FOCUSED FEASIBILITY STUDY – GROUNDWATER

ANIAK MIDDLE SCHOOL ANIAK, ALASKA

FINAL
June 2012

ALASKA
Department of
Environmental
Conservation

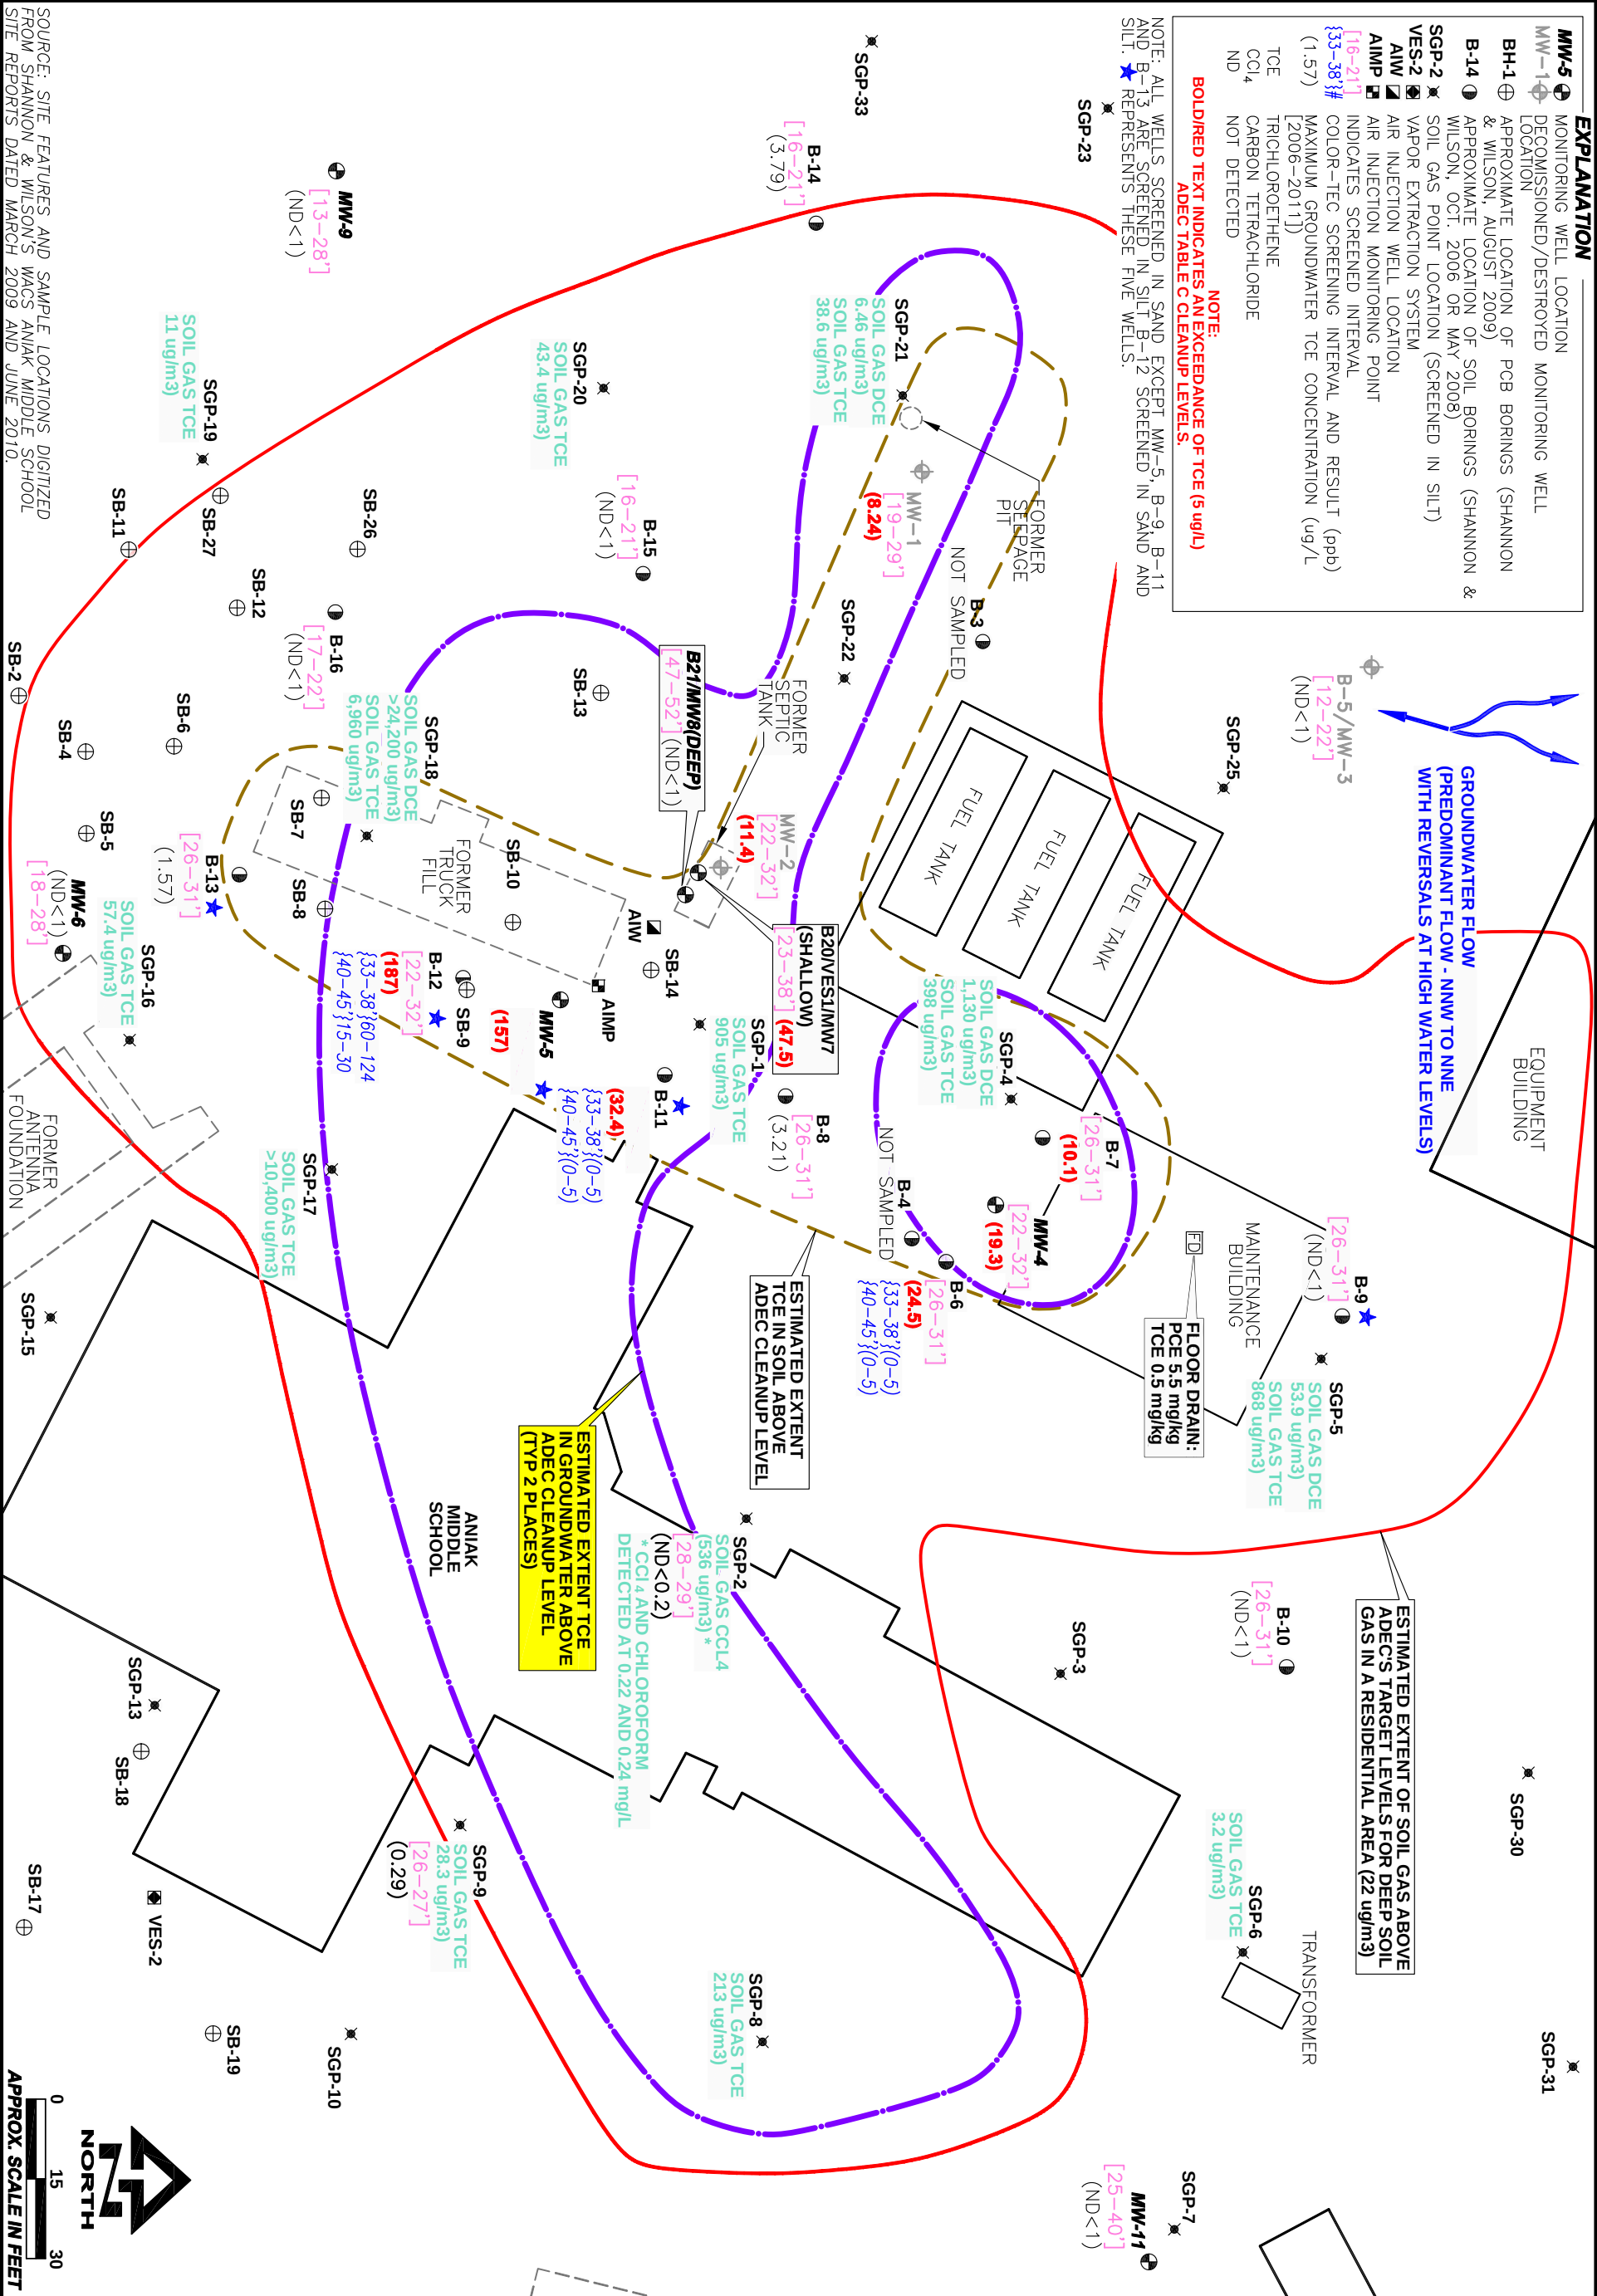
2.	Figure 3	B20/VES1/MW7 (shallow) is shown as shaded, which indicates it has been decommissioned/destroyed. Please clarify.	The monitoring wells in this area are mislabeled and will be labeled correctly for the final report. The shaded well is MW-2; the one labeled B21/MW8 should actually be B20/VES1/MW7 (shallow), and the well to the right of that should be B21/MW8.
